Customer Process Change Notification Form

PCN-2013-501

CS5480-INZ(R)

Errata: CS5480 Rev B2 Silicon

Figure 1. Chip Select Pin \overline{CS} Model

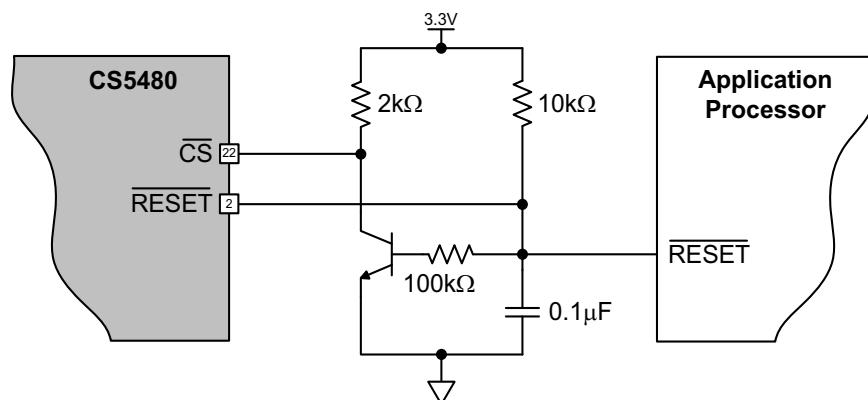
Erratum 3 - Serial Peripheral Interface Communication Synchronization Error

This erratum applies only to designs with chip select pin \overline{CS} tied low. If Serial Peripheral Interface (SPI) communication is interrupted, a synchronization error may occur on future SPI communications. A standard reset does not clear the SPI logic and correct this synchronization error.

Chip select pin \overline{CS} must be toggled to reset the SPI Interface. A NPN inverter may be added to the \overline{RESET} signal to obtain a suitable CS signal to reset the SPI Interface without the need for additional isolators. When the device is reset, using \overline{RESET} , the serial peripheral interface is also reset.
